GRADING PLAN

HILTON AVE. LOFTS

DRAINAGE PLAN

TITLE:	GRADING PLAN - FOR INFORMATION ONLY HILTON AVE. LOFTS
--------	--

C2.0

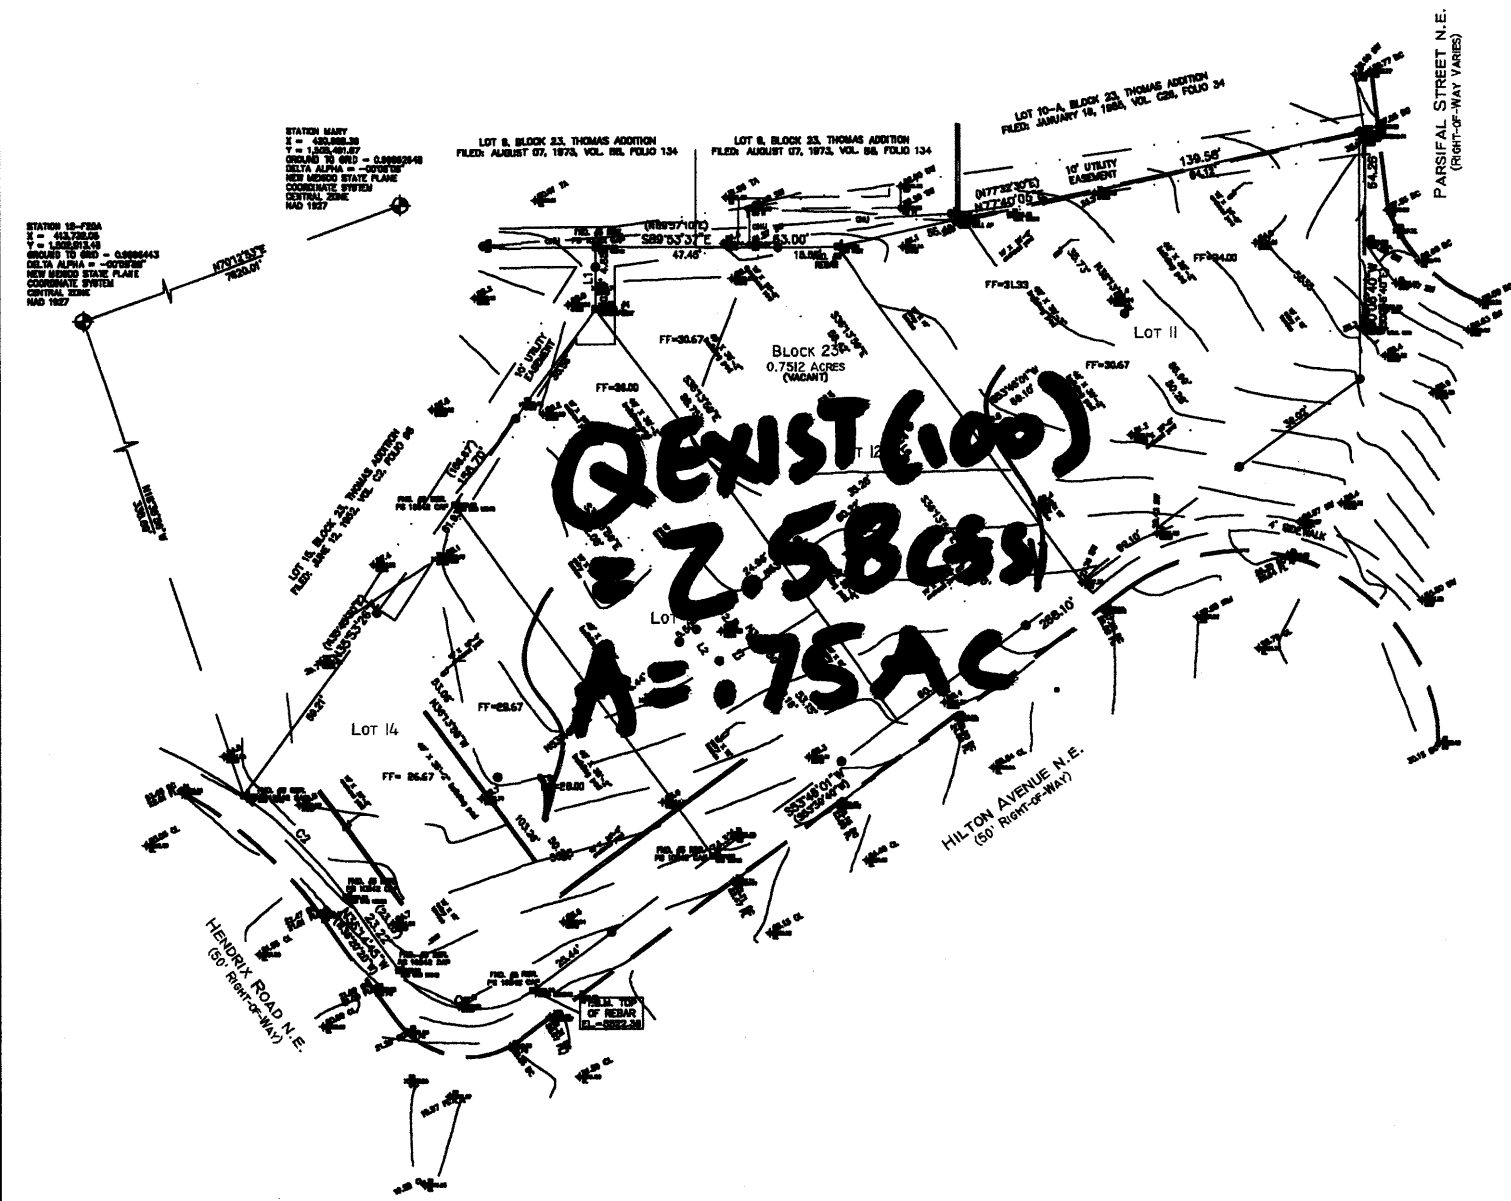
INDICATED BY THE AS-BUILT INFORMATION SHOWN HEREON, THIS PROJECT APPEARS TO HAVE BEEN CONSTRUCTED IN SUBSTANTIAL COMPLIANCE WITH THE INTENT OF THE APPROVED GRADING AND DRAINAGE PLAN. HOWEVER, THE HILTON AVENUE LOFTS HOME OWNERS ASSOCIATION WILL COMPLETE FINAL LANDSCAPING CONSTRUCTION TO ADDRESS THE FOLLOWING ITEMS:

AREA A) OBTAIN & IMPLEMENT ADDITIONAL RECOMMENDATIONS FROM VINYARD AND ASSOCIATES TO ACCOMMODATE THE LANDSCAPING & IRRIGATION IN THE LANDSCAPED AREA ADJACENT TO AND NORTH OF BUILDING 8, OR REMOVE THE PLANT MATERIAL, IRRIGATION AND REPAVE THE PLANTER AREA.

AREA B) UPON INSTALLATION OF LANDSCAPING: STEEPEN THE SWALE BETWEEN LOTS 5/7 & 6 FROM THE MID POINT OF THE EAST PROPERTY LINE - SOUTH TO THE HILTON AVE. RIGHT-OF-WAY.

AREA C) THE NEWLY CONSTRUCTED CONCRETE SIDEWALK AT THE NORTH SIDE OF LOT 5 SHALL HAVE AN INVERTED SWALE CONSTRUCTED TO CONVEY SURFACE FLOWS TO THE "NOTCHED" AREA OF THE ADJACENT CONCRETE RUNDOWN. NO IRRIGATION OR PLANT MATERIAL SHOULD BE INSTALLED IN THIS AREA NORTH OF LOT 5 AND NORTHEAST OF LOT 4.

AREA D) UPON LANDSCAPING, STEEPEN THE SWALE ALONG THE LOWER FACE OF THE PLANTER WALL EAST OF THE BUILDING ON LOT 6 TO CONVEY SURFACE FLOWS AWAY FROM THE STRUCTURE AND THROUGH THE OPENING IN THE GARDEN WALL TO THE SOUTH.

LANDSCAPING AT ROOF DRAINS AND PLANTERS) ALL ROOF DRAINS AND PLANTER AREAS MUST COMPLY WITH WATER PROOFING AND LIMITED IRRIGATION RECOMMENDATIONS PER THE VINYARD & ASSOCIATES SOILS REPORT -DATED 9/9/05 OR OBTAIN & IMPLEMENT ADDITIONAL RECOMMENDATIONS FROM VINYARD AND ASSOCIATES.

C2.1

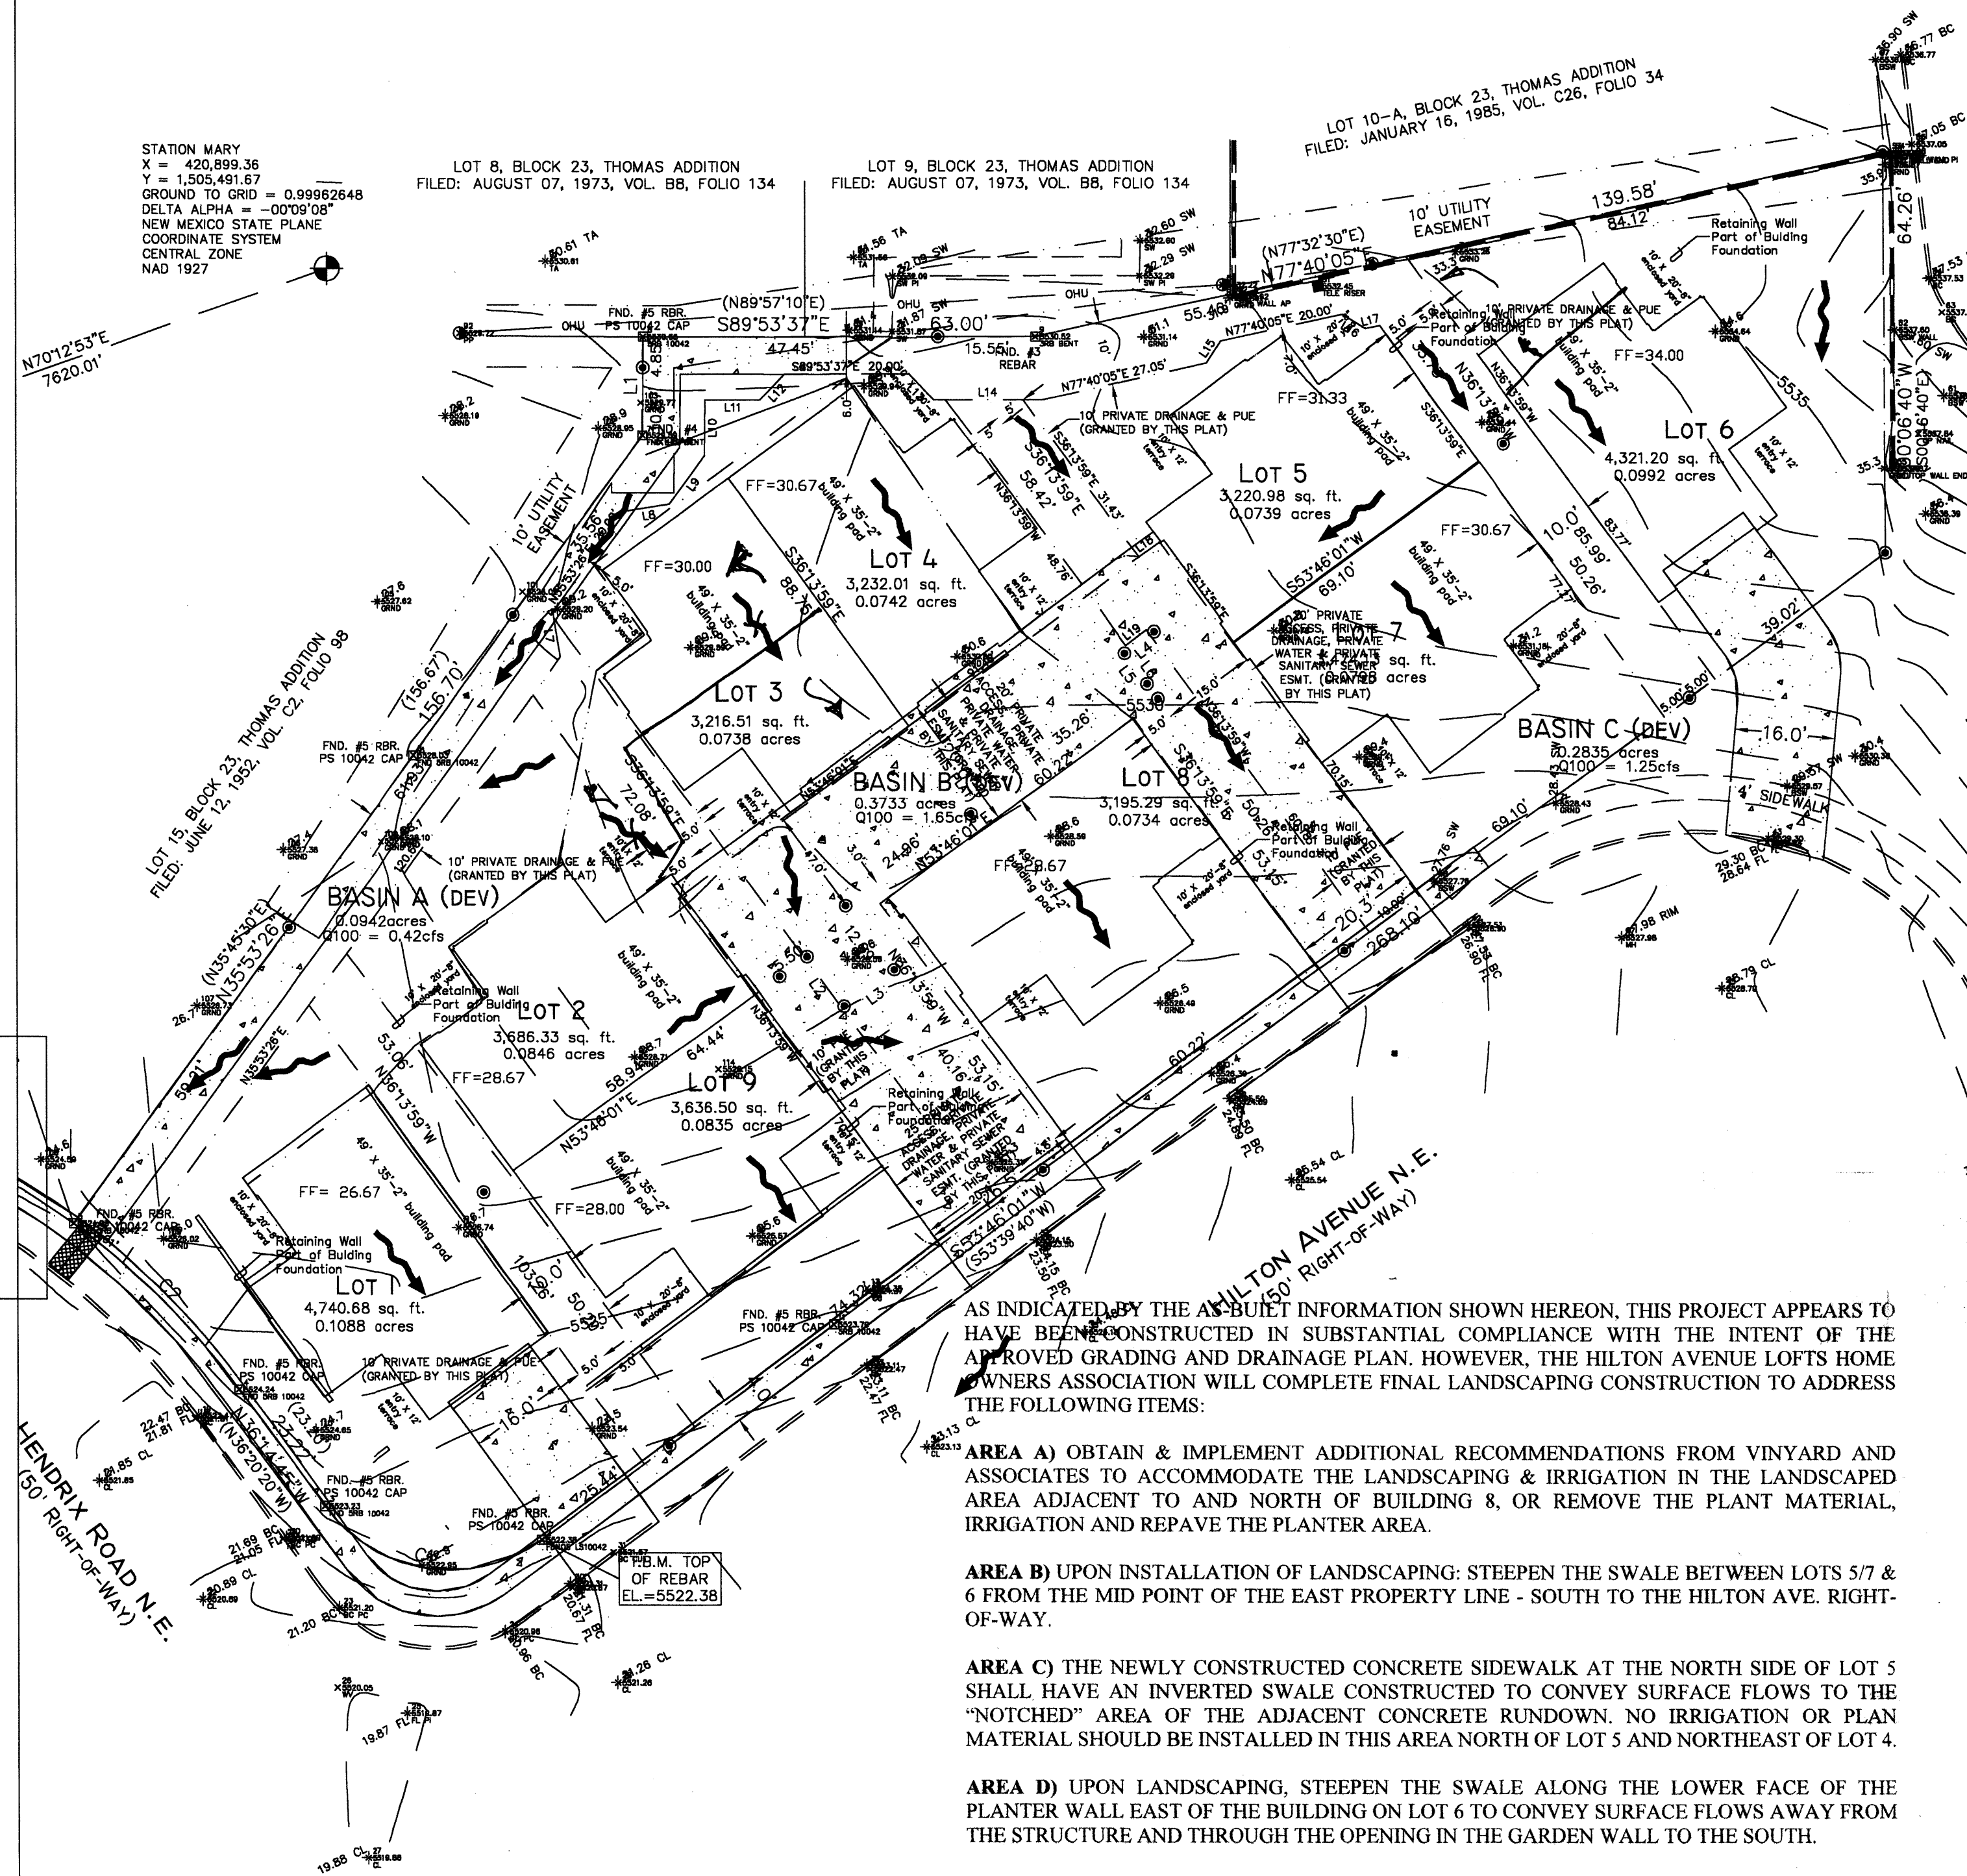
AS INDICATED BY THE AS-BUILT INFORMATION SHOWN HEREON, THIS PROJECT APPEARS TO HAVE BEEN CONSTRUCTED IN SUBSTANTIAL COMPLIANCE WITH THE INTENT OF THE APPROVED GRADING AND DRAINAGE PLAN. HOWEVER, THE HILTON AVENUE LOFTS HOME OWNERS ASSOCIATION WILL COMPLETE FINAL LANDSCAPING CONSTRUCTION TO ADDRESS THE FOLLOWING ITEMS:

AREA A) OBTAIN & IMPLEMENT ADDITIONAL RECOMMENDATIONS FROM VINYARD AND ASSOCIATES TO ACCOMMODATE THE LANDSCAPING & IRRIGATION IN THE LANDSCAPED AREA ADJACENT TO AND NORTH OF BUILDING 8, OR REMOVE THE PLANT MATERIAL, IRRIGATION AND REPAVE THE PLANTER AREA.

AREA B) UPON INSTALLATION OF LANDSCAPING: STEEPEN THE SWALE BETWEEN LOTS 5/7 & 6 FROM THE MID POINT OF THE EAST PROPERTY LINE - SOUTH TO THE HILTON AVE. RIGHT-OF-WAY.

AREA C) THE NEWLY CONSTRUCTED CONCRETE SIDEWALK AT THE NORTH SIDE OF LOT 5 SHALL HAVE AN INVERTED SWALE CONSTRUCTED TO CONVEY SURFACE FLOWS TO THE "NOTCHED" AREA OF THE ADJACENT CONCRETE RUNDOWN. NO IRRIGATION OR PLANT MATERIAL SHOULD BE INSTALLED IN THIS AREA NORTH OF LOT 5 AND NORTHEAST OF LOT 4.

AREA D) UPON LANDSCAPING, STEEPEN THE SWALE ALONG THE LOWER FACE OF THE PLANTER WALL EAST OF THE BUILDING ON LOT 6 TO CONVEY SURFACE FLOWS AWAY FROM THE STRUCTURE AND THROUGH THE OPENING IN THE GARDEN WALL TO THE SOUTH.

LANDSCAPING AT ROOF DRAINS AND PLANTERS) ALL ROOF DRAINS AND PLANTER AREAS MUST COMPLY WITH WATER PROOFING AND LIMITED IRRIGATION RECOMMENDATIONS PER THE VINYARD & ASSOCIATES SOILS REPORT - DATED 9/9/05 OR OBTAIN & IMPLEMENT ADDITIONAL RECOMMENDATIONS FROM VINYARD AND ASSOCIATES.
